# REPORT

**To:** New Westminster Design Panel  
**From:** Michael Watson,  
Senior Development Planner  
**Date:** March 26, 2024  
**File:** REZ00191  
SDP00225  
**Item #:** 2024-159  
**Subject:** **811 Carnarvon St – Rezoning Application and Special Development Permit for 44 Storey Mixed-Use Development**

Figure 19 Potential cross section for upper Eighth Street (Royal to Carnarvon) looking north

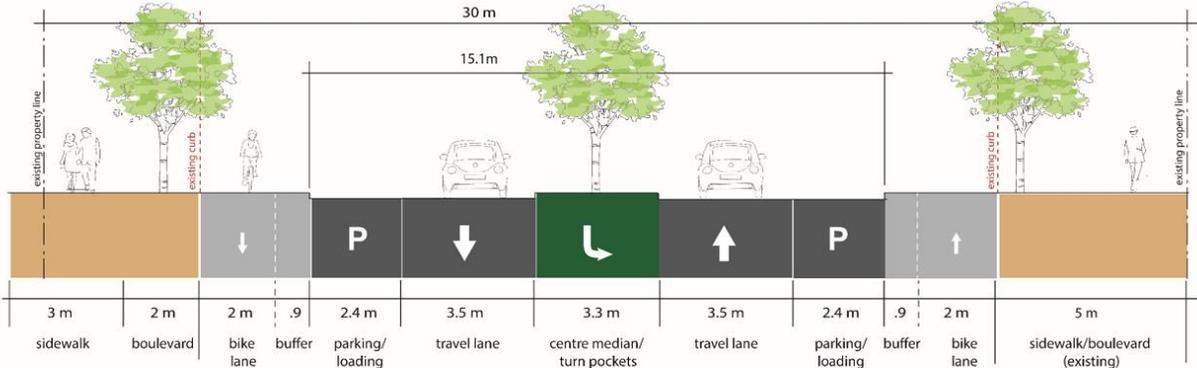
The proposal transitions from a residential frontage at Eighth and Agnes Streets to a retail frontage at Carnarvon Street. To address grade along the retail portion of the frontage, the building has been setback 3.7 metres (12.1 feet) and has a secondary walkway parallel for access to five retail units separated from the public sidewalk by retaining walls and landscaping. There is limited space would be available for retail activities to spill outdoors into the space in front of the units and a perception of separation of the retail from the public sidewalk.

In regards to Eighth Street the right of way is expected to include a sidewalk with a minimum width of 3.0 metres plus a 2.0 metre landscaped boulevard, 0.9 metre bike lane, street tress, pedestrian scale lighting, weather protection and benches and seating opportunities. A conceptual cross section from the Downtown Transportation Plan is included below
